The Supreme Court of Ohio

ADDENDUM #2

RFQ No. 301

REPLACEMENT AND INSTALLATION OF FRAME MOUNTED END SUCTION HOT WATER PUMPS

Figure 4: Current Butterfly Valve specifications

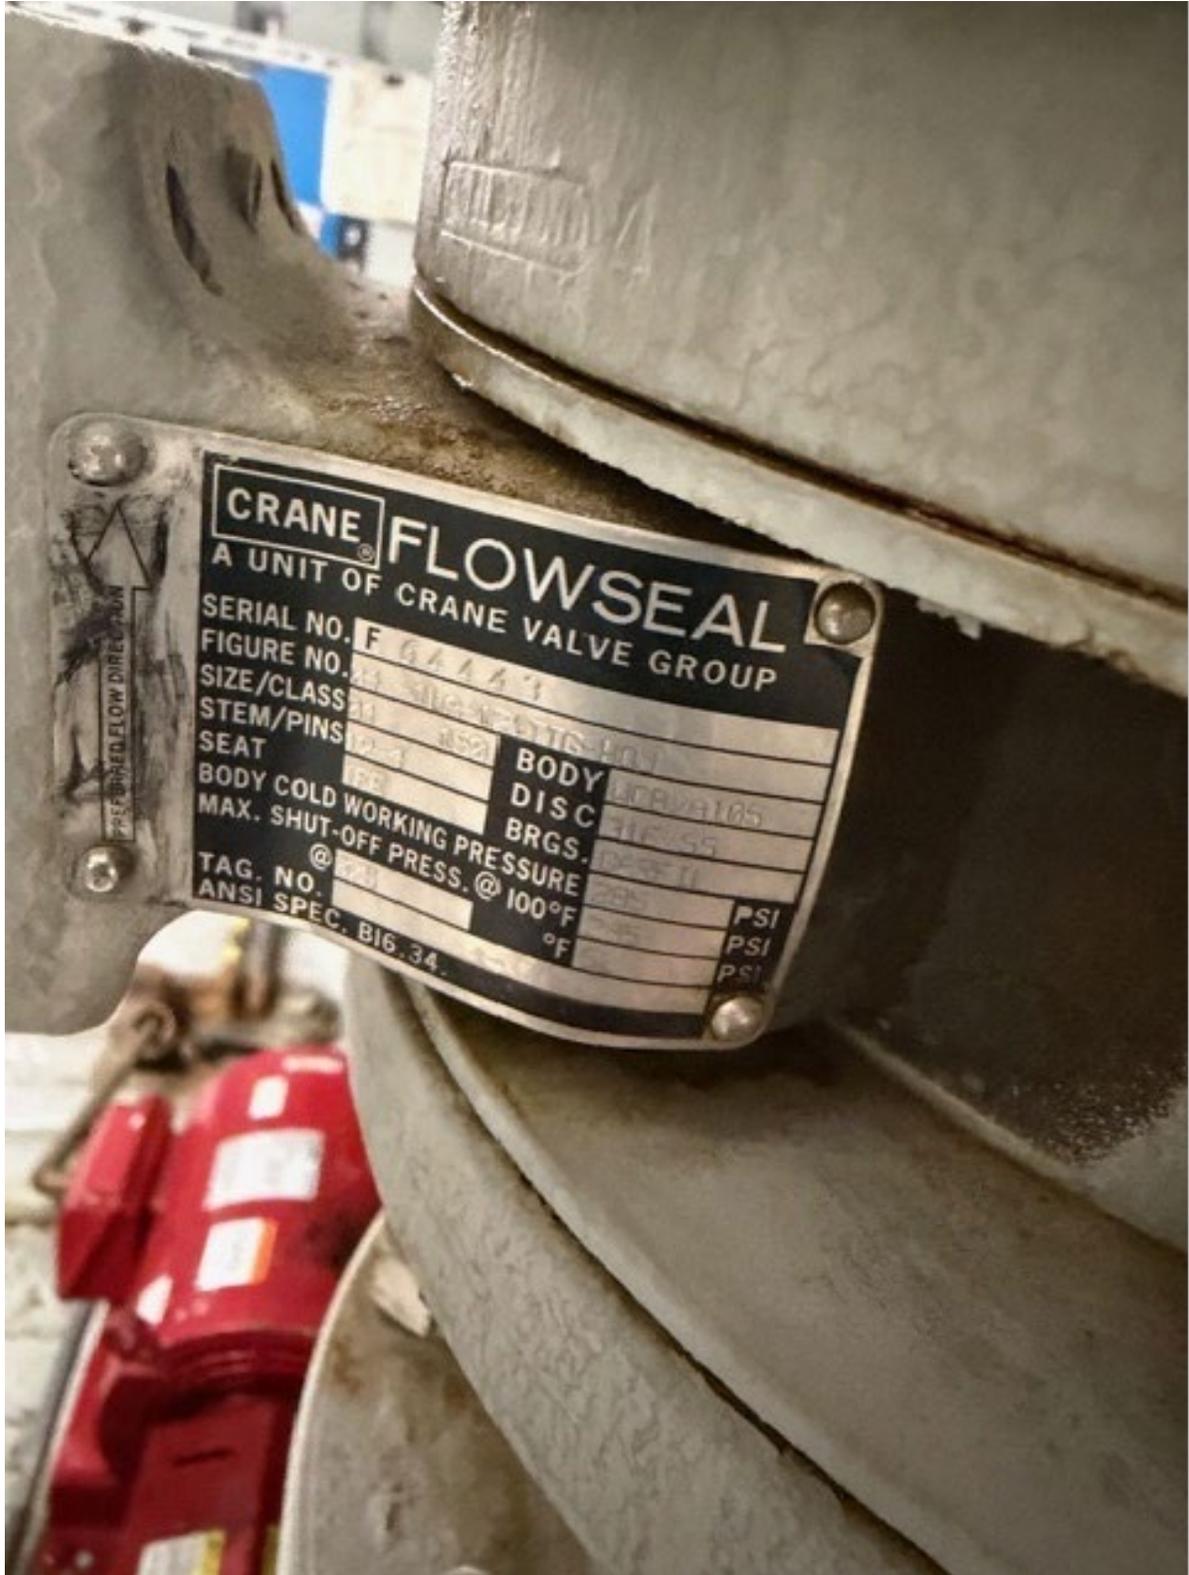
- a. Rubber Expansion Joints
 - i. Five total: 4-inch (quantity: 2) and 6-inch (quantity: 3)
- b. Suction Diffuser/Strainer
 - i. Quantity: 5
- c. Triple Duty Valve
 - i. Quantity: 2 (one for each primary loop)
- d. Silent Check Valve
 - i. Quantity: 3 (one for each secondary loop)
- e. Butterfly Valves
 - i. Quantity: 10 (See attached Figure 5 for current Butterfly Valve specifications)
 - ii. (Please submit pricing under one of the *Additional costs* fields of **Appendix B**)
- f. Flex Couplers
 - i. Five total: 4-inch (quantity: 2) and 6-inch (quantity: 3)
 - ii. (Please submit pricing under one of the *Additional costs* fields of **Appendix B**)
